# D/DRC Case

1219 Assembly Street

**DESIGN/DEVELOPMENT REVIEW COMMISSION**  
**DESIGN REVIEW DISTRICT**  
**CONSENT AGENDA**  
**EVALUATION SHEET**  
Case # 5

**NATURE OF REQUEST:** Request for Certificate of Design Approval for exterior changes and preliminary certification of the Bailey Bill

NEW EAST ELEVATION AT ASSEMBLY STREET

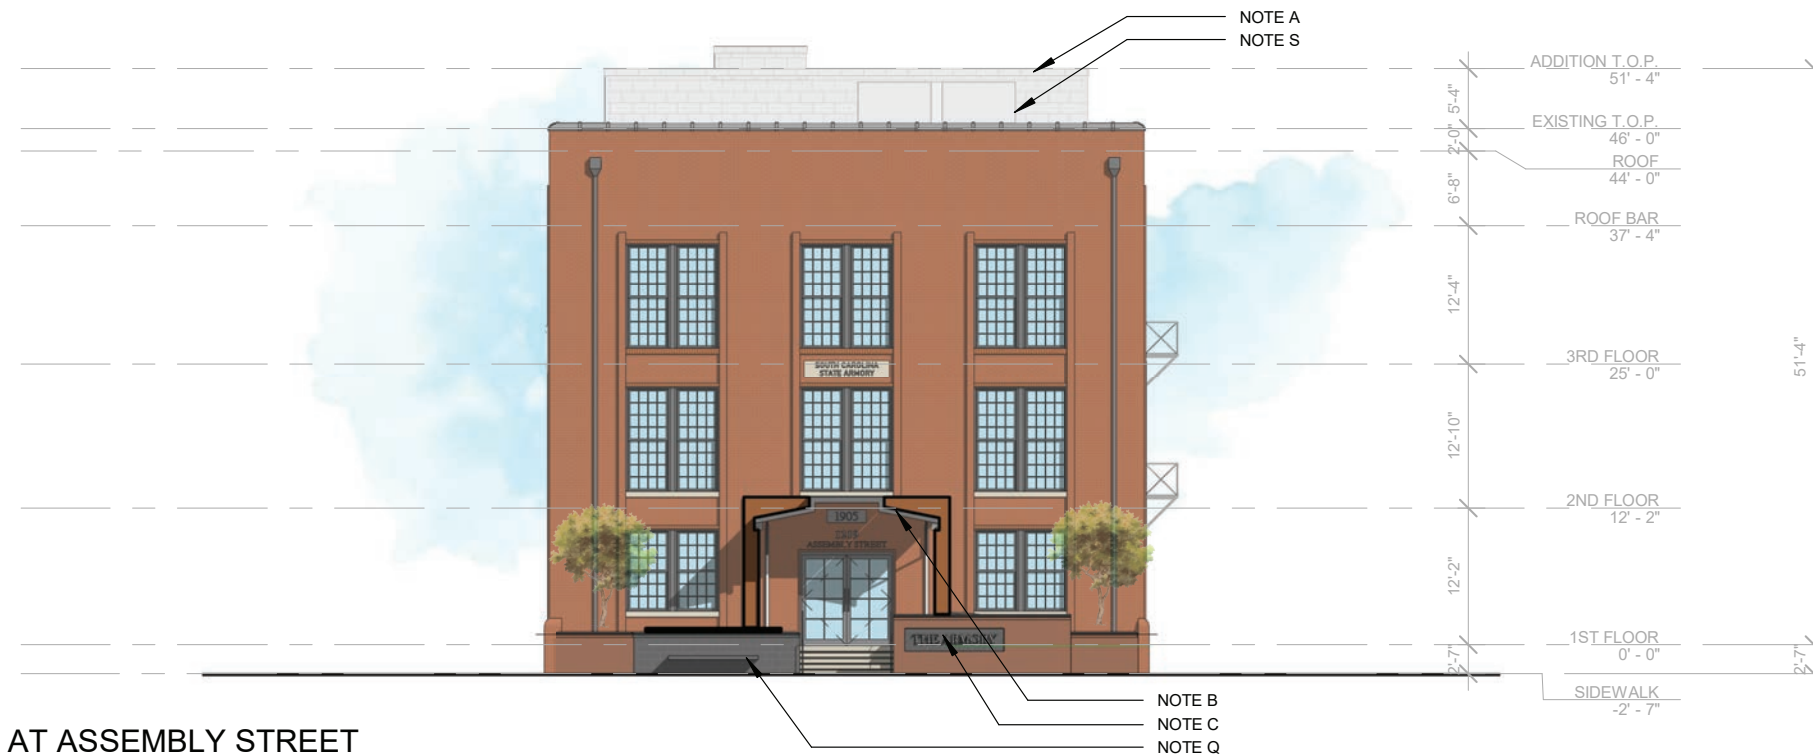
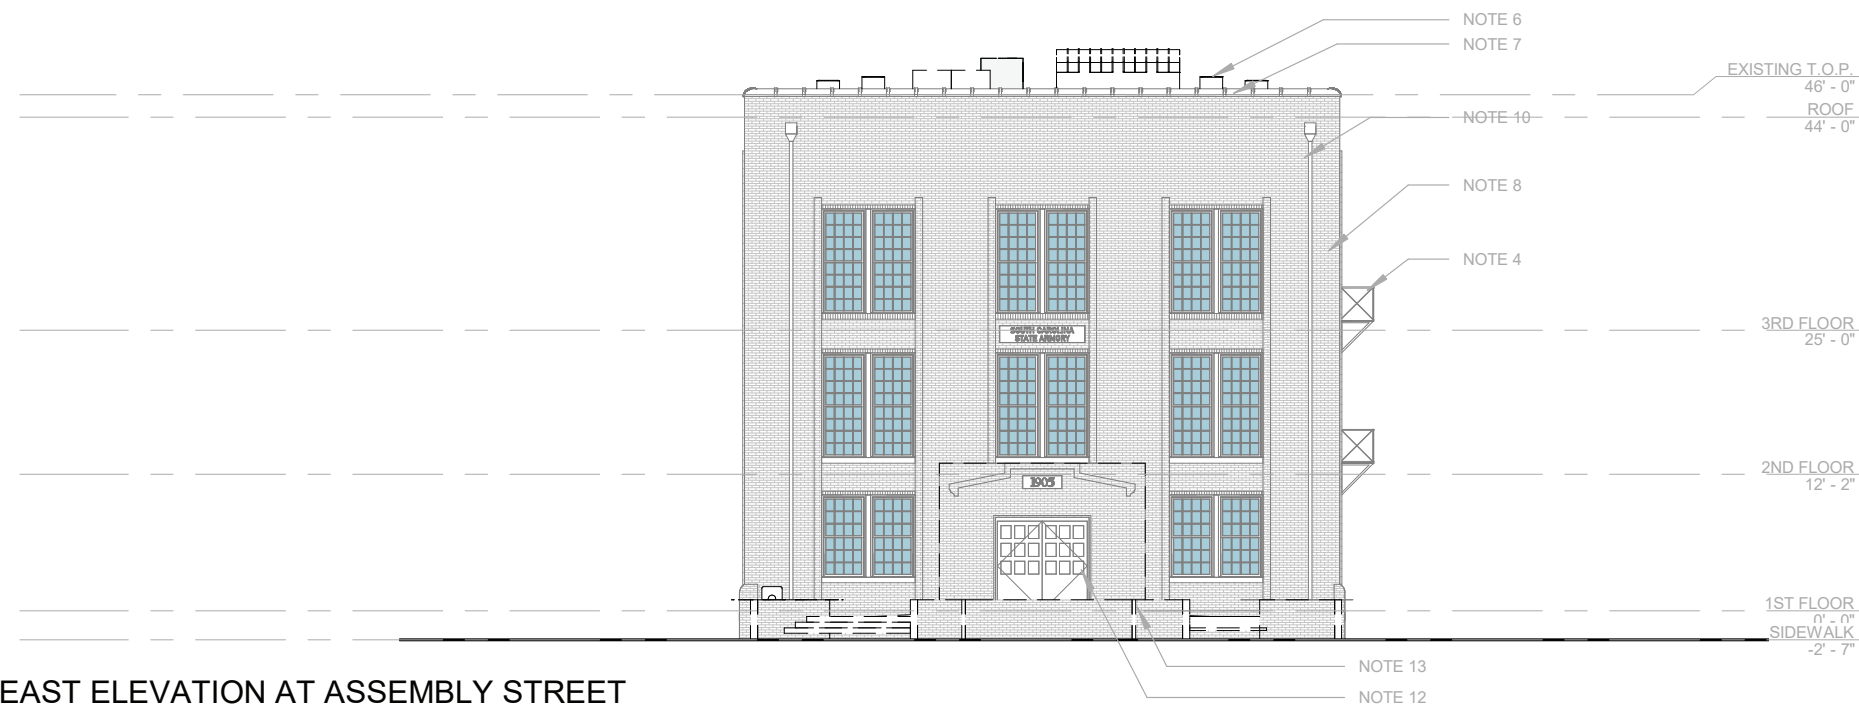
The front door of the building is either the original front door or is a good replica of the original/historic 9-light door; the proposed new front door is an 8-light, full glass door, not matching the old door and therefore not in keeping with this standard. As such, staff recommends altering the proposal for the front door: if additional investigation finds the door is original, the front doors should be maintained and repaired with modifications to meet modern code; or, if the front door is found to be non-original, the front door may be removed with a new door fabricated to replicate the historic 9-light door.

The canopy structure proposed for the entryway is designed as a freestanding structure so that it does not connect to the historic building entry at all and will therefore not destroy any historic materials at the entry.

- The front door proposal be altered to maintain and repair or replicate the historic 9-light doors;
- The project meeting or exceeding the 20% investment threshold requirements for qualified rehabilitation expenses;
- All work meeting the standards for work as outlined in Section 17-698;
- All details deferred to staff.
